EVALUATION OF THE SUITABILITY OF THE WIPP SITE

Environmental Evaluation Group  
Environmental Improvement Division  
Health and Environment Department  
State of New Mexico

May 1983

Figure 7. Encounter of brine in the Castile Formation.

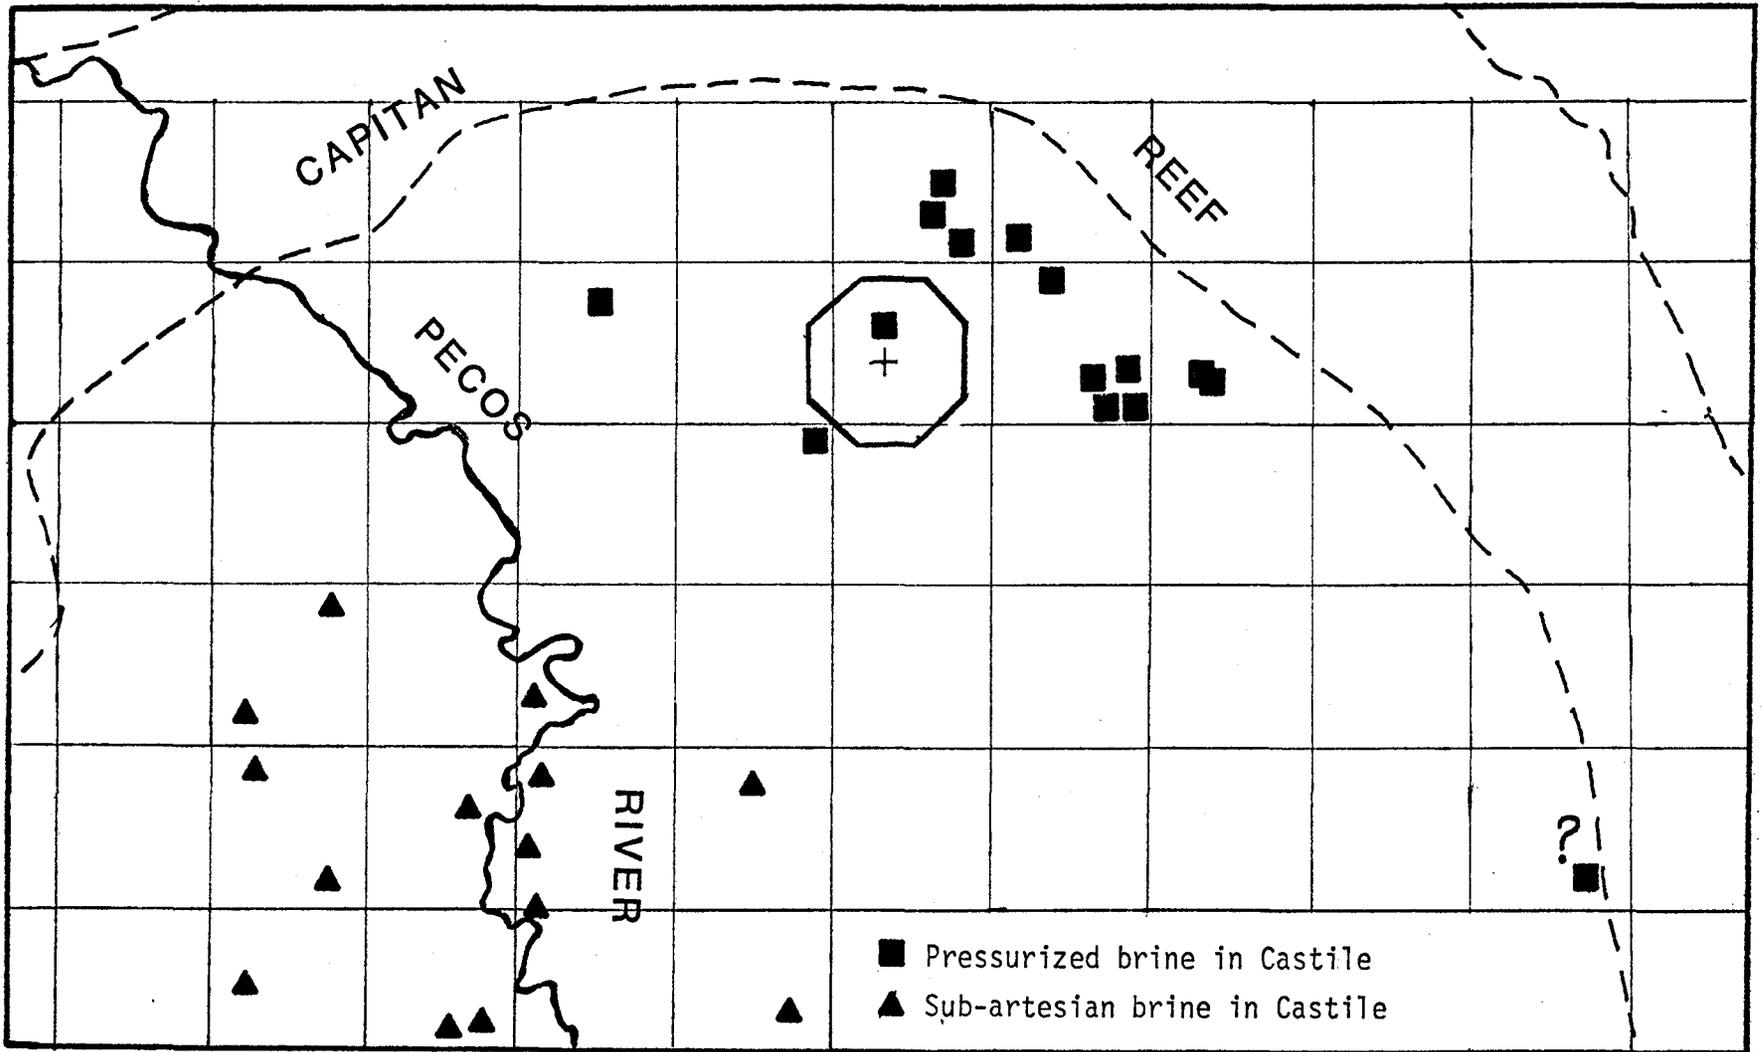
From Figure 7, it appears that the brine encounters in boreholes do not occur randomly. Two large groups of encounters are observed northeast and east of the WIPP site. The location of these two groups appears to indicate a relationship between the pressurized brines and the Capitan Reef. The WIPP-12, Belco, and Danford encounters are isolated and away from the Reef. Although non-random, the occurrences do not follow a consistent pattern.

Figure 11. Aerial extent of the brines assuming a circle centered at the borehole for various reservoir thicknesses,  $K = 2 \times 10^6$  psi.

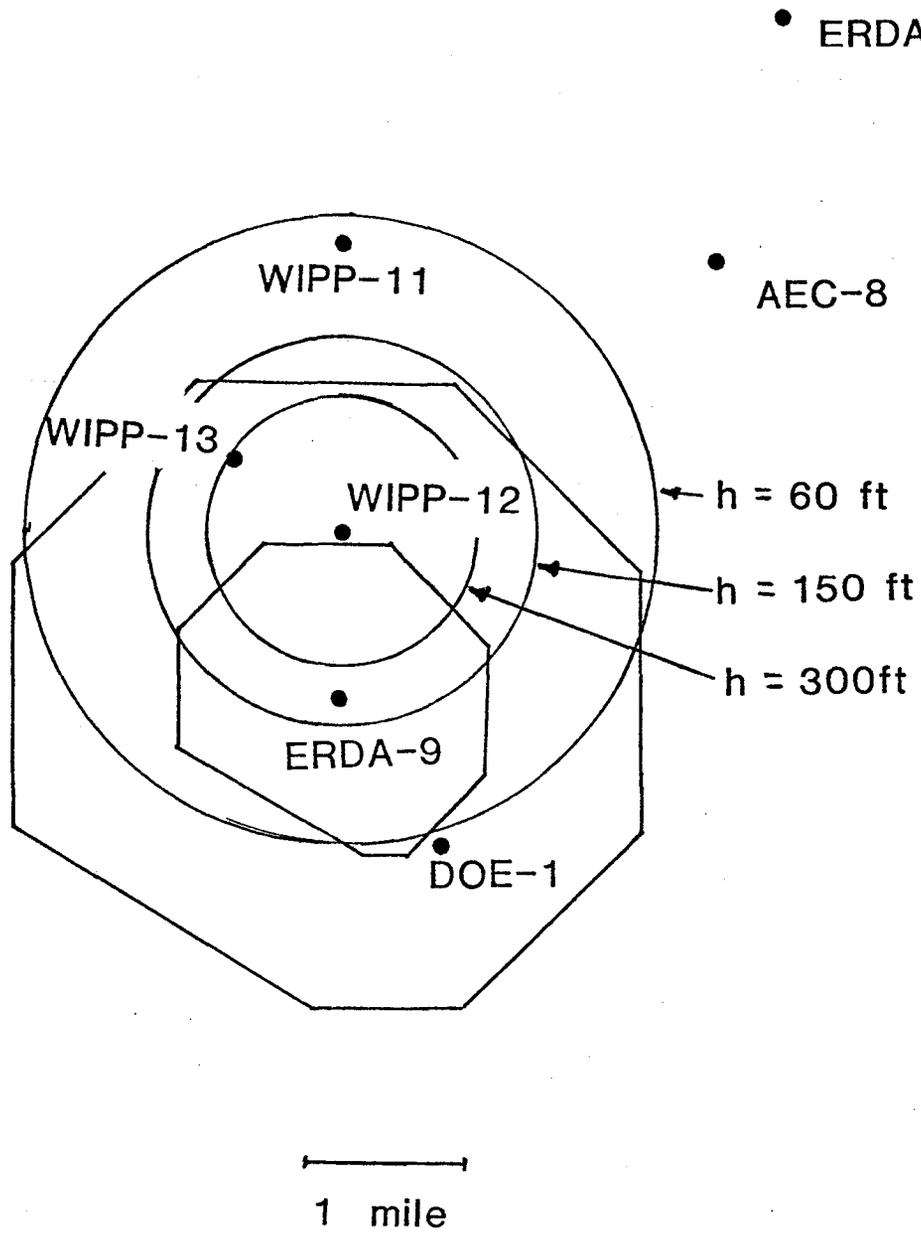
Figure 11 is a map of the WIPP site showing the area of the WIPP-12 brine assuming the bulk modulus  $K = 2 \times 10^6$  psi for various reservoir thicknesses. Also included on Figure 11 is the seismic time structure on the middle of the Castile. The calculated areas for WIPP-12 all extend well beyond the limits of the apparent domal structure.

Figure 17a. Geophysical logs of borehole AEC-8 and intervals that EEG contends should have been tested (logs adapted from SAND79-0269, 1983)

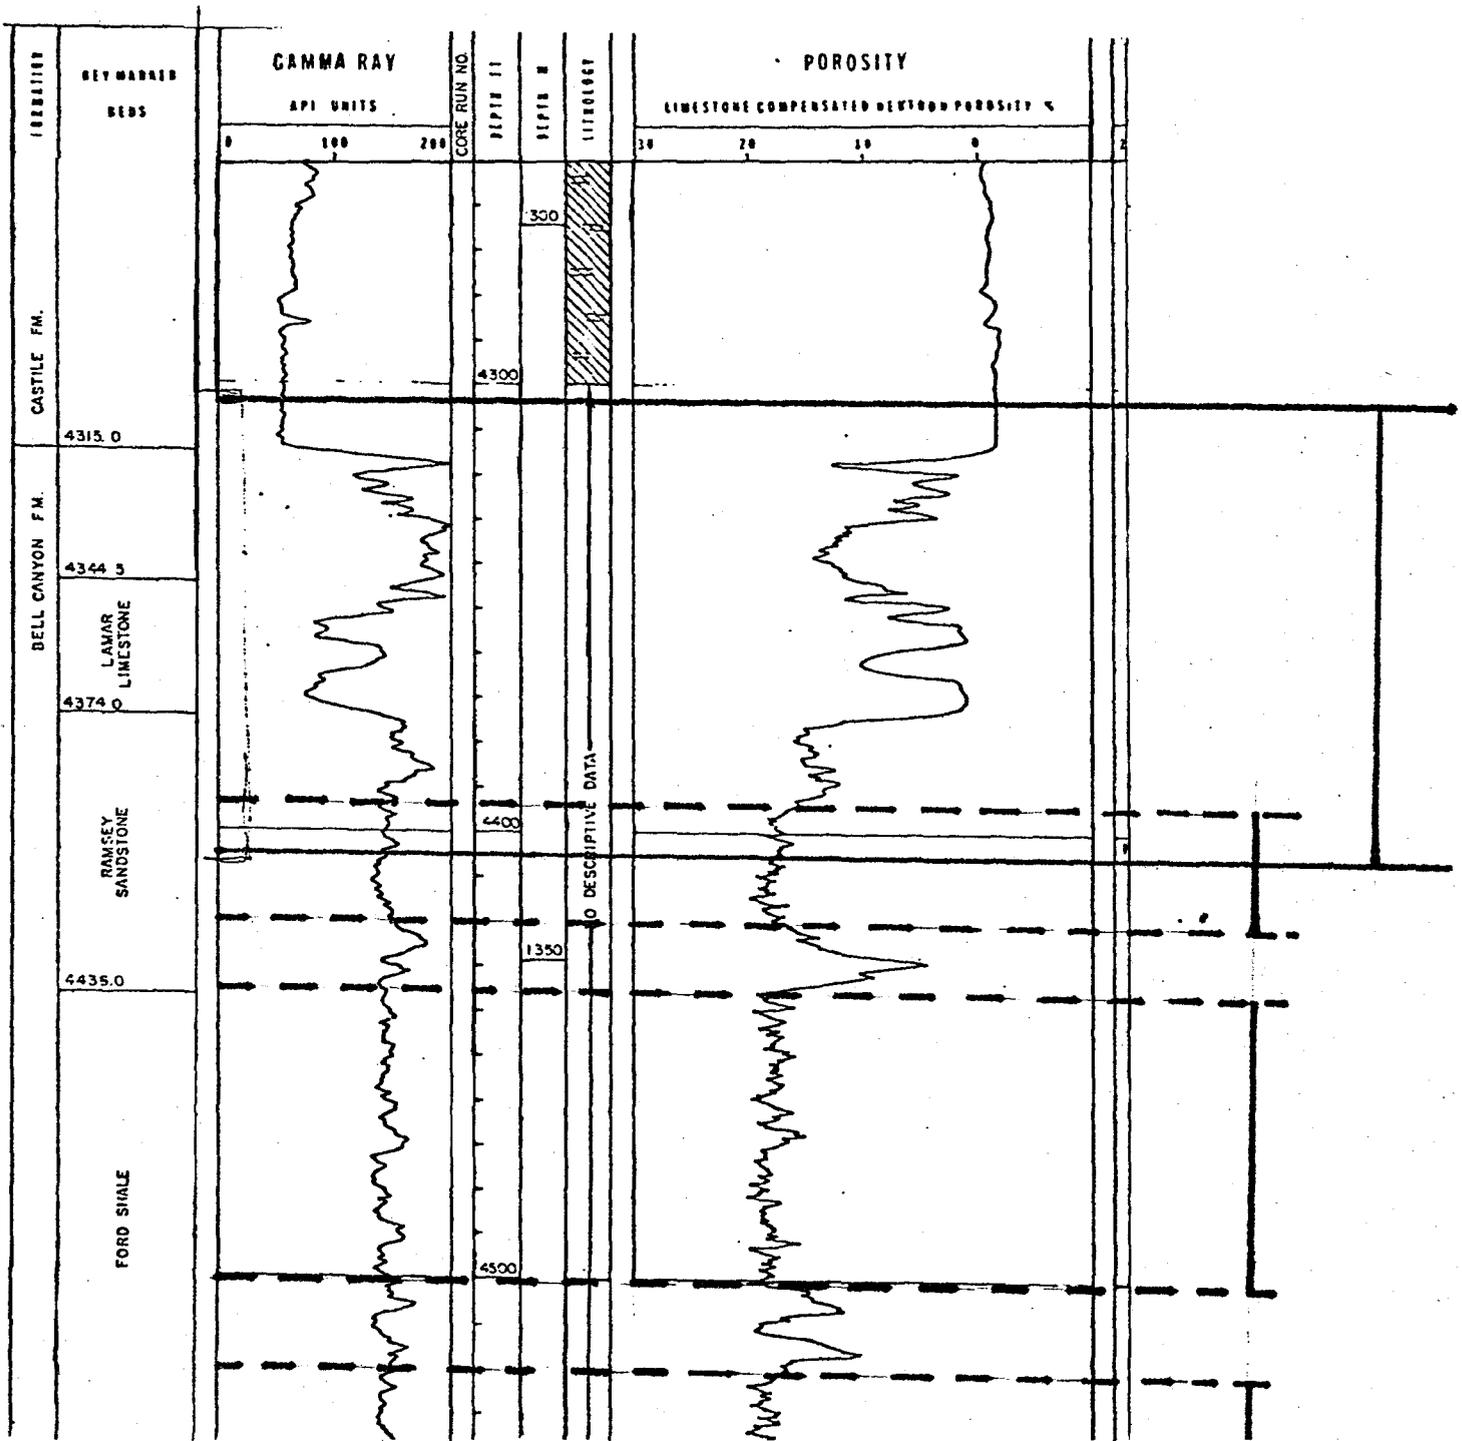
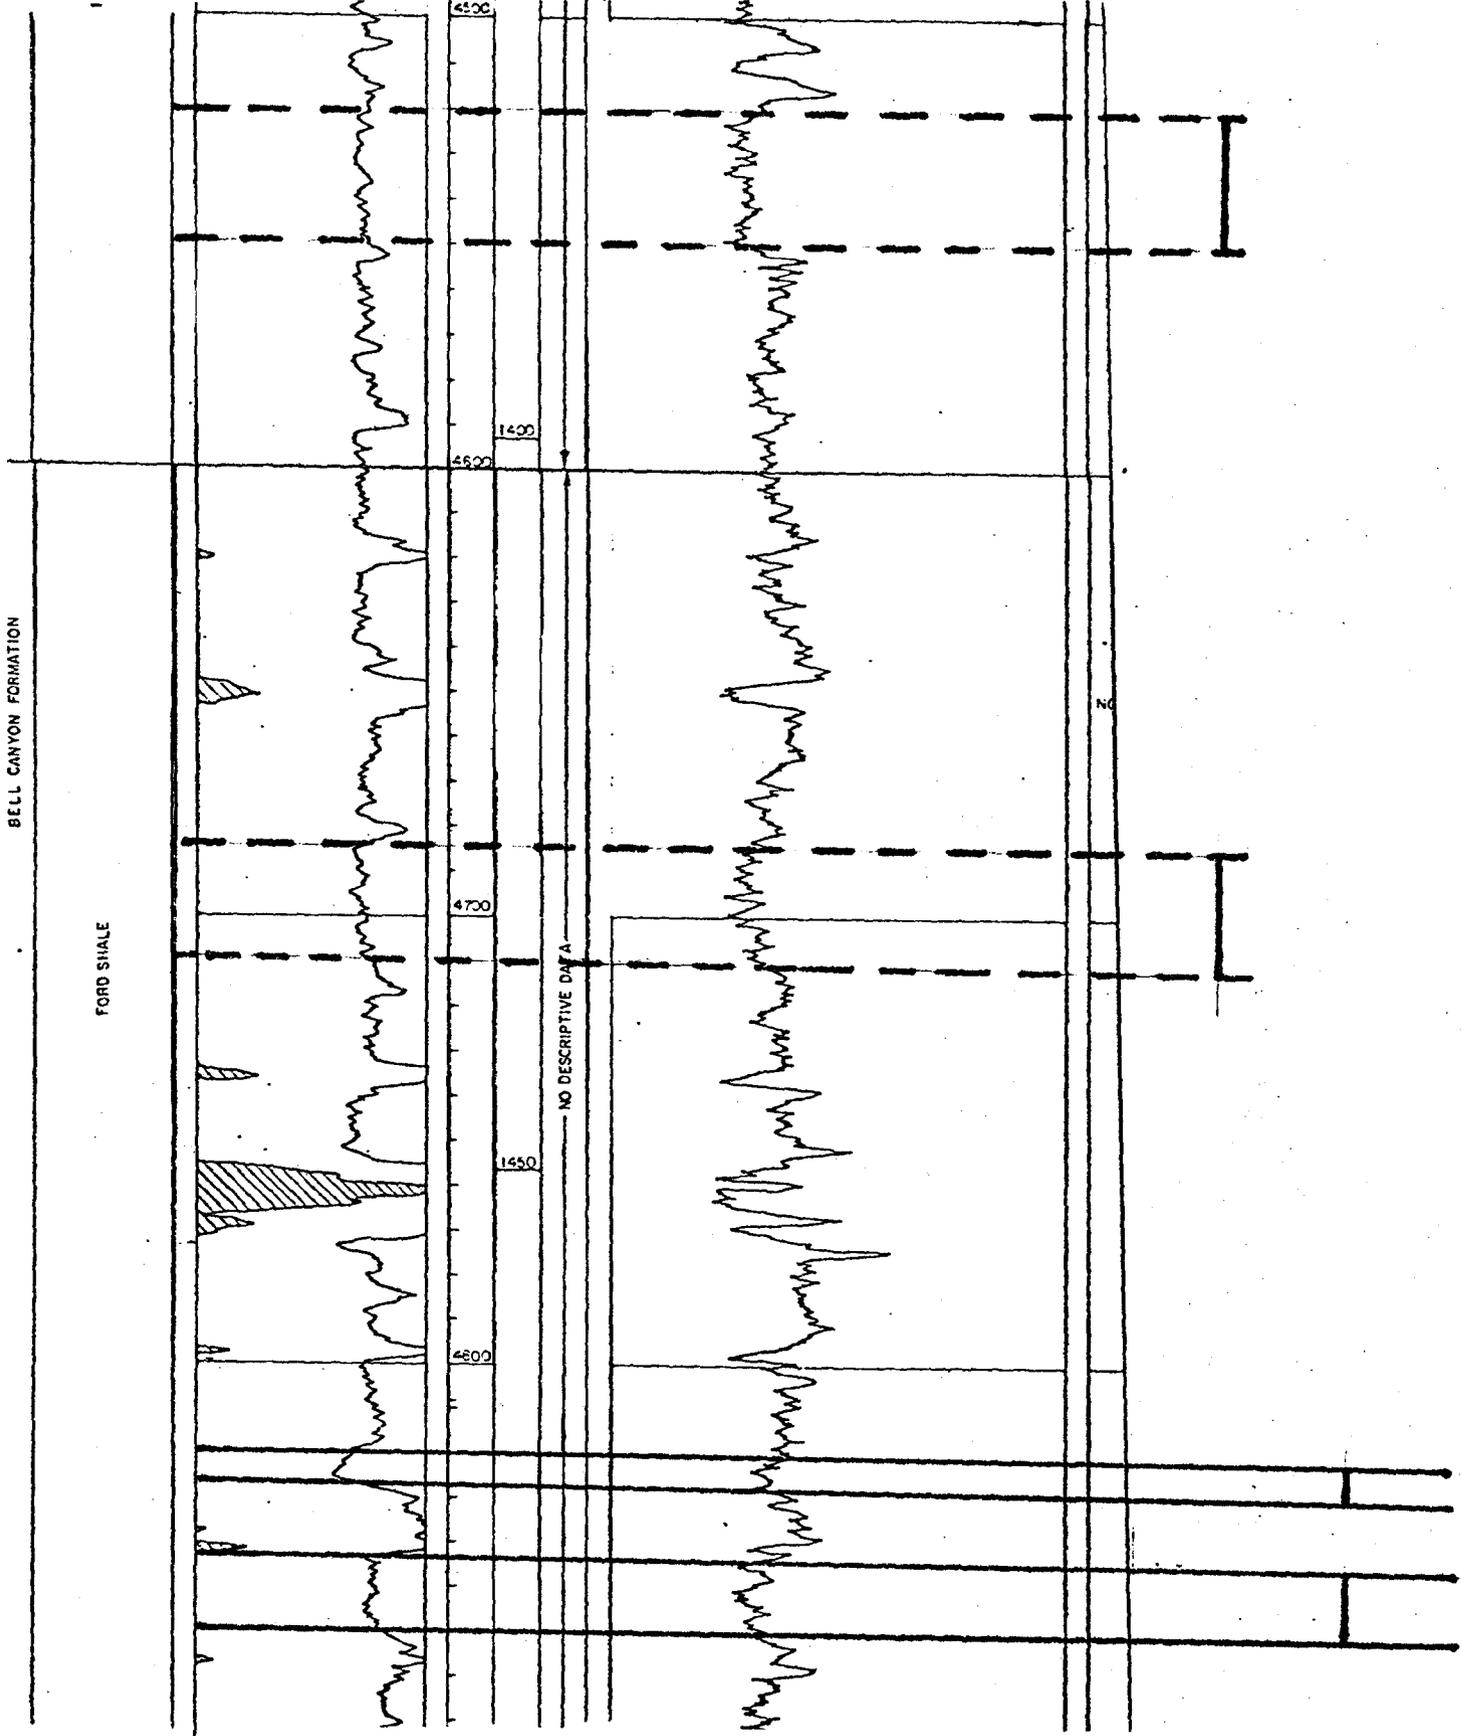
- The intervals tested in test hole AEC-8 appear to completely bypass the Ramsey sandstone member. Geophysical logs of the upper Bell Canyon including the 2 tested intervals are presented in Figure 17. The two sand units were chosen for testing because "The natural gamma log indicated that the two units were predominantly sandstone and the porosity log indicated that they

had greater porosities than other Bell Canyon sand units." (Mercer and Orr, 1979, p. 127). Four other sand units, not tested, which possess very similar geophysical log signatures as the intervals tested are indicated on Figure 17. These other untested sand units with a combined thickness of 150 feet, are stratigraphically closer to the repository and would have been logical intervals to test.

Figure 23. WIPP Site and the southern limits of the "Highly Disturbed Area" (GCR), the "Zone of Anomalous Seismic Reflection Data" and the "Steepening of Dip of Castile Strata" (SAR).

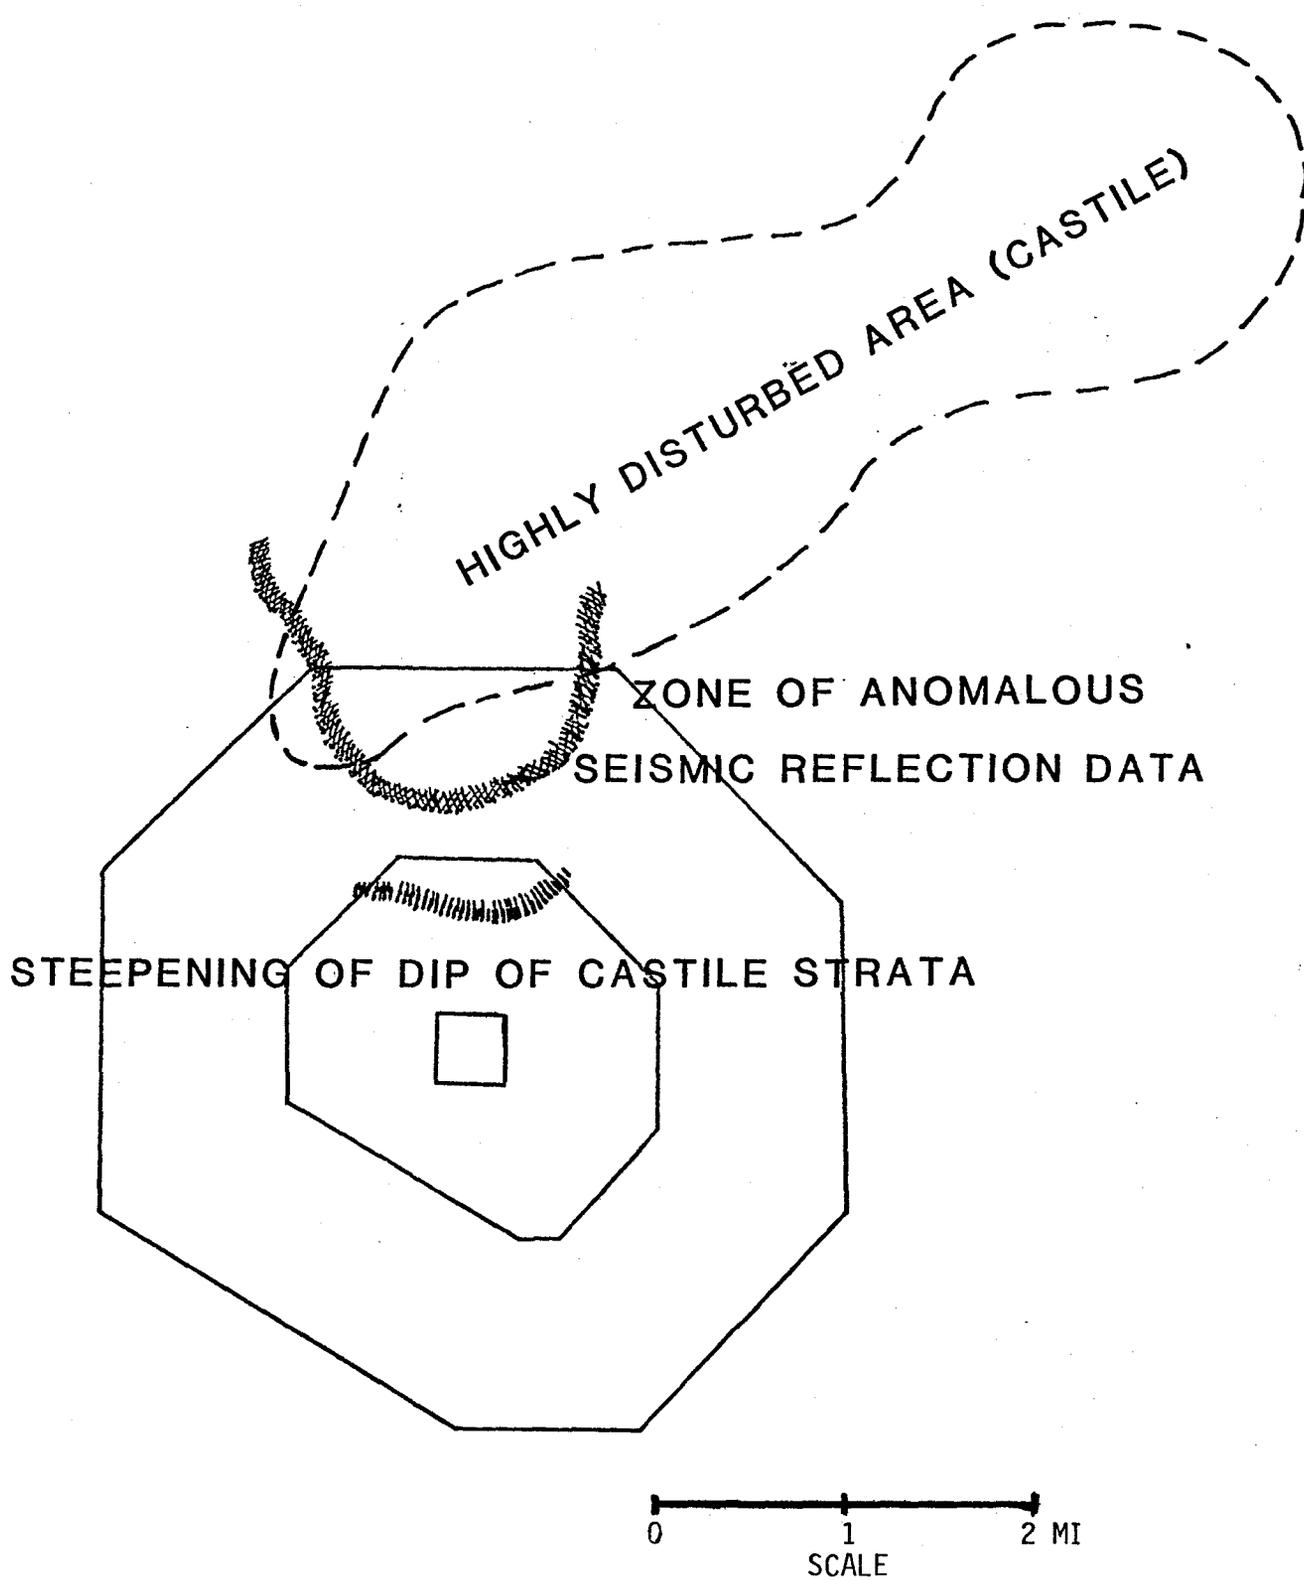
In earlier DOE publications, e.g. Powers et al (1978) and Register (1981)\*, the disturbed zone was presented as a zone bordering the Capitan Reef. Borns et al (1983) have widened this zone to include the WIPP-12 structure where brine was encountered. In addition, they have shown two more areas, to the southwest and south of the WIPP site (Fig. 23), as part of DZ. No rational explanation has been provided for separating these two areas from the band bordering the reef. The seismic profiles do show structures between WIPP-12 and Belco-Hudson well, but there are no wells penetrating the Castile formation between these two and, therefore, the boundary of the circular DZ shown southwest of the site in Figure 23 is arbitrary.

Because of the absence of identifiable boundaries of DZ and the lack of an adequate explanation for a limited areal extent, it seems logical to conclude that some structural complexity in the Castile formation may exist to varying degrees anywhere in the northern Delaware Basin including the WIPP site.
